SLG46855-EV Errata Note

This document contains the known errata for SLG46855-EV and the recommended workarounds.

Figure 1: Example Data

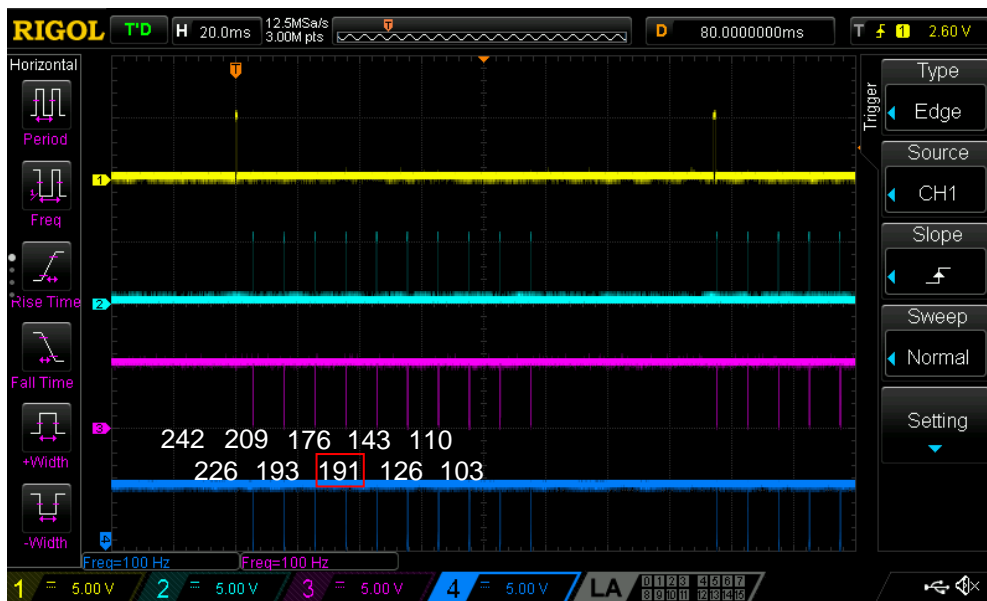
Asynchronous interaction between the CNT/DLY clock input and the I²C latch signal (generated by an I²C read command of the CNT/DLY block’s count value) can result in an incorrect I²C data read. The CNT/DLY block will count accurately, but the count value transferred into the block’s I²C read register might be loaded incompletely if the I²C latch signal and the clock input occur at about the same time.

The example data capture below shows ten periodic I²C reads of CNT2/DLY2 configured to count down at about 16 clocks per read. The sixth read sample erroneously shows a value greater than that of the fifth. The seventh sample reads as if the previous I²C error never occurred - the difference from the fifth sample (176) to the seventh (143) is 33 clocks or 16 clocks + 17 clocks as expected.

If the possibility of incorrect I²C data reads can’t be accommodated for by external software checks, one can guarantee proper operation by stopping the CNT/DLY block’s clock during I²C reads through one of the following methods: by disabling the oscillator block, by reconfiguring the CNT/DLY block’s clock source, or by gating an external clock using a LUT (Look Up Table) in the signal matrix. After disabling the CNT/DLY block’s clock, the count registers can be read without error. Please note that this workaround will add the I²C read and processing time to the counter’s overall clock period.

The best workaround depends on the resource constraints of the application. If the oscillator block doesn't clock other logic elements within the design, a matrix output can be used to manually power down the oscillators for the I²C read. When the CNT/DLY block's clock source is routed internally from the oscillator block, I²C commands can temporarily reconfigure the CNT/DLY block's clock source registers to select "Ext. CLK. (From Matrix)." This action will disable the clock by connecting it to the ground. If the CNT/DLY block is clocked from the signal matrix, the LUT can be used to gate the clock during the I²C read.

Figure 2: GreenPAK Input Structure Test Schematic

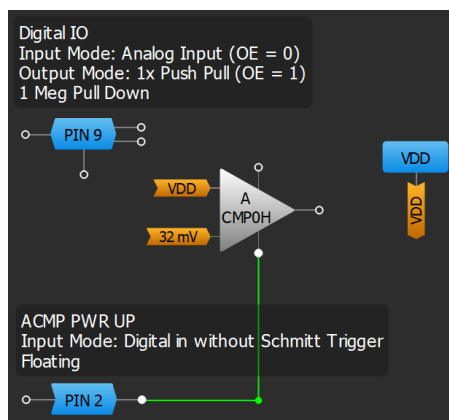
Figure 2 shows the GreenPAK configured with GPIO4 as a Digital IO with a 1 MΩ pull-down resistor. Since the OE pin is connected to 0 V, this pin is acting as an “Analog IO.” As seen in Table 1, GPIO4 and V_{DD} are both input options for ACMP0H. In this example, GPIO is being used as a digital input to enable and disable the ACMP.

There is no workaround for this behavior. With this in mind, the GPIOs should not be used as digital IOs (with "Input mode" set to Analog input) or as digital outputs (with "Output mode" set to 1/2/4x 3-State Output) if the respective ACMP is enabled and connected to another input source.

Figure 3: ACMP Input Structure Behavior

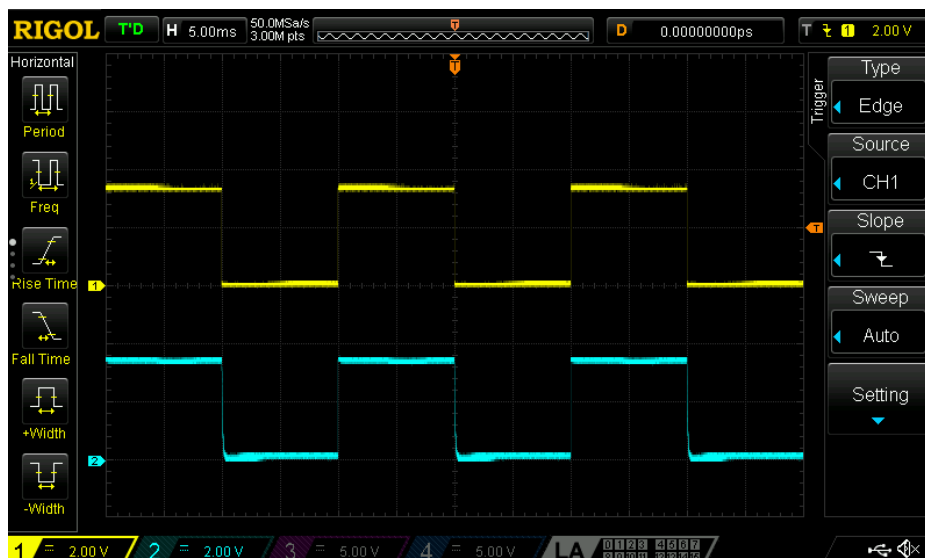
Figure 3 shows that GPIO4 in analog input mode is pulled HIGH by the V_{DD} signal whenever the ACMP is enabled despite having an internal pull-down resistor. This behavior is caused by an internal connection between V_{DD} and GPIO4. Similar behavior can be reproduced when one ACMP’s IN+ port is connected to another ACMP’s IN+ port.

Figure 5: ACMP Output during Glitching

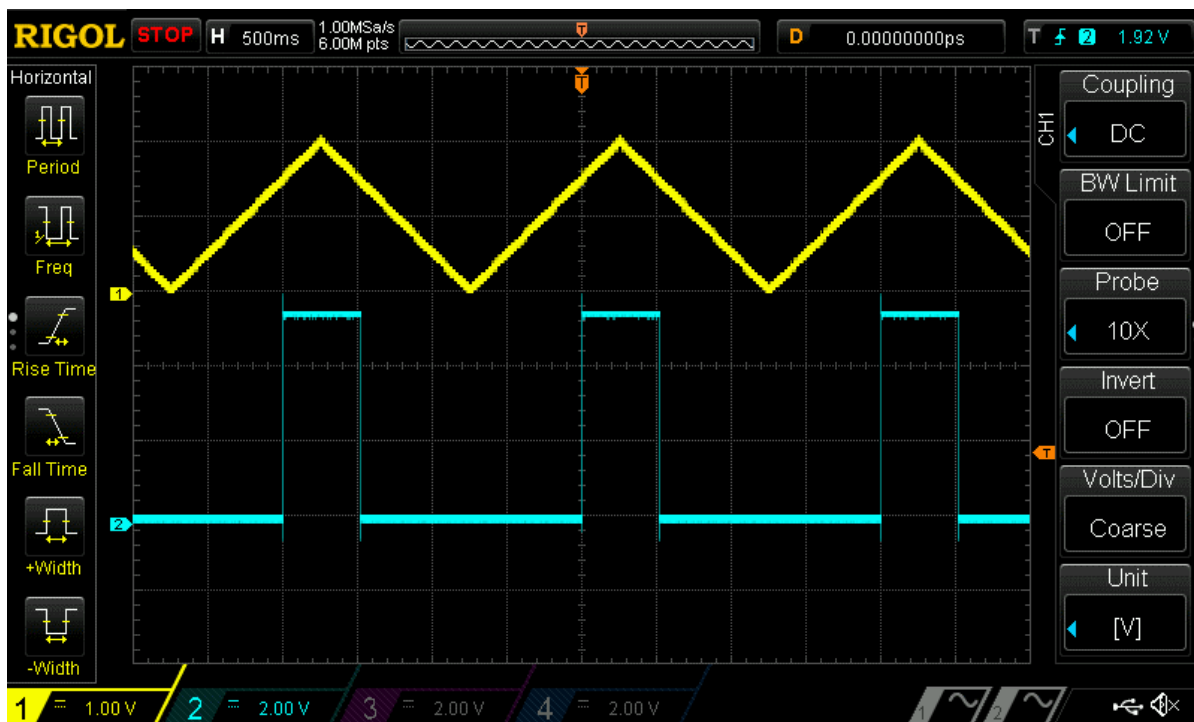
If using ACMPxH with 32 mV or 64 mV hysteresis, ACMPxH output could be glitching when ACMPxH positive input (IN+) is close to the negative input (IN-). It can happen when $V_{DD} = 4.6$ V or higher and V_{ref} is in a range from 1.312 V to 2.016 V for 32 mV hysteresis, and V_{ref} is in a range from 1.312 V to 1.696 V for 64 mV hysteresis.

1. Waveform at $V_{ref} = 1504 \text{ mV}$, hysteresis is equal to 32 mV .

- Use the deglitch filter connected to the ACMPxH output.
- Avoid conditions described in paragraph 3.3.2.

Figure 6: Zoomed ACMP Output during Glitching

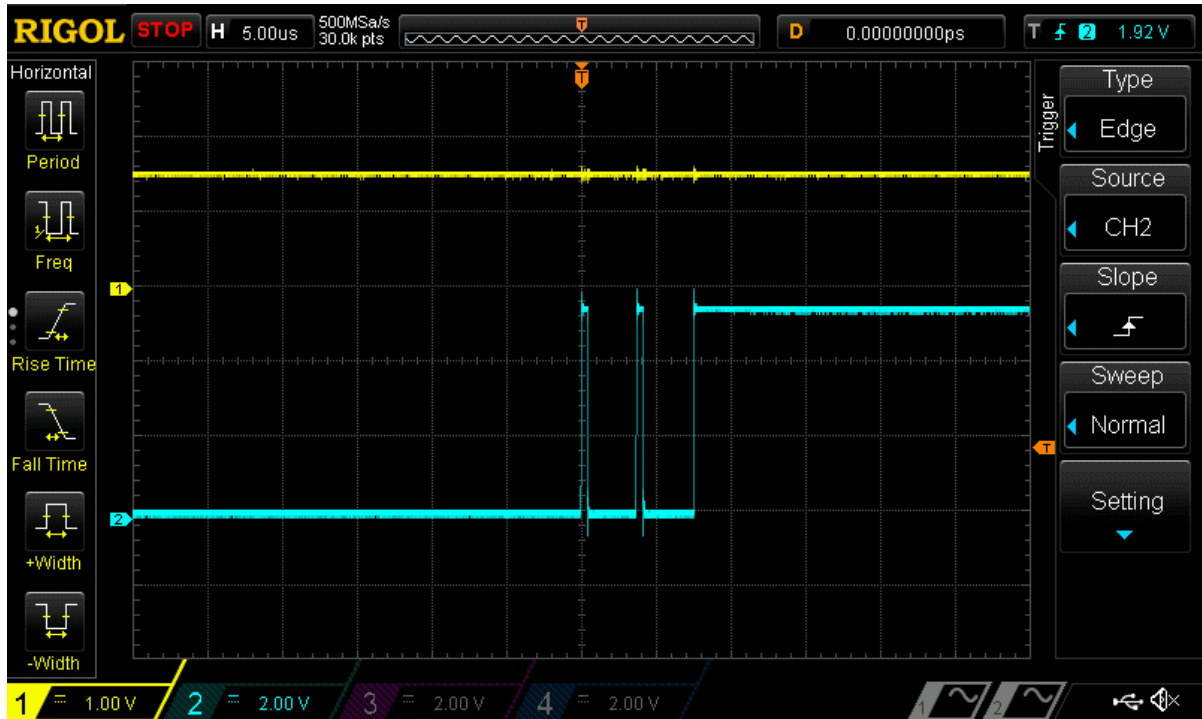
2. Waveform at $V_{ref} = 1504 \text{ mV}$, hysteresis is equal to 32 mV (zoomed rising edge).
